Proposal: Partial demolition of existing garage structure & replace with two storey side extension.

Site: Feildings, Hoe Lane, Flansham, PO22 8NW.

Y/27/18/HH

Southern Water MapGuide Browser

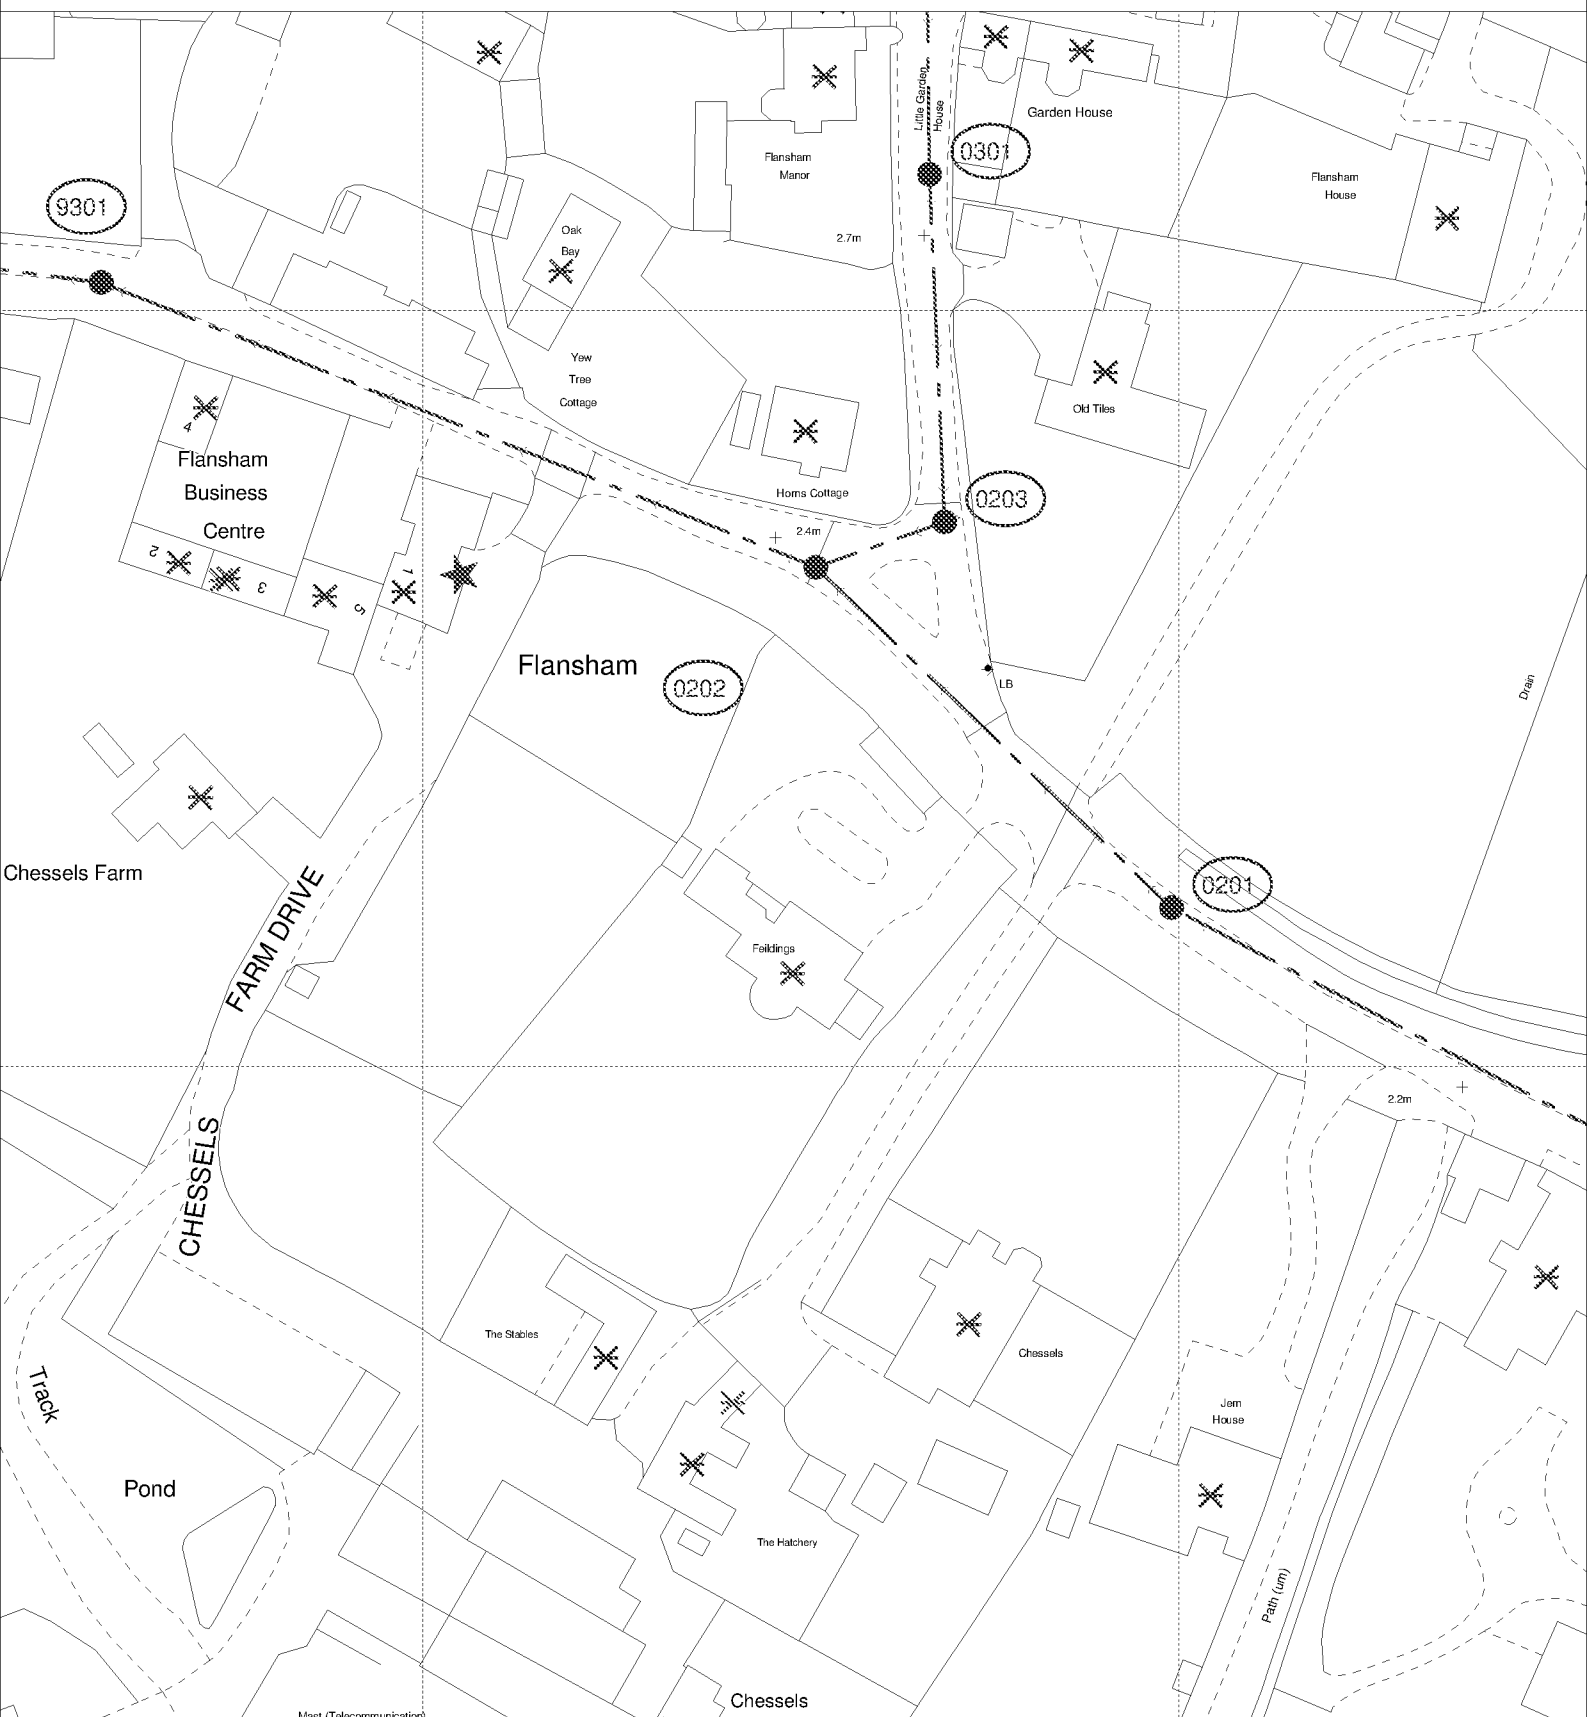
Due to surface water inundation issues in the Lidsey Catchment "The applicant is advised to adopt, where appropriate, the measures in the table "Practical measures to reduce the potential impacts of development".

Developer should look to protect the public sewerage system from inundation and infiltration, which contribute to flooding in unfavourable conditions.
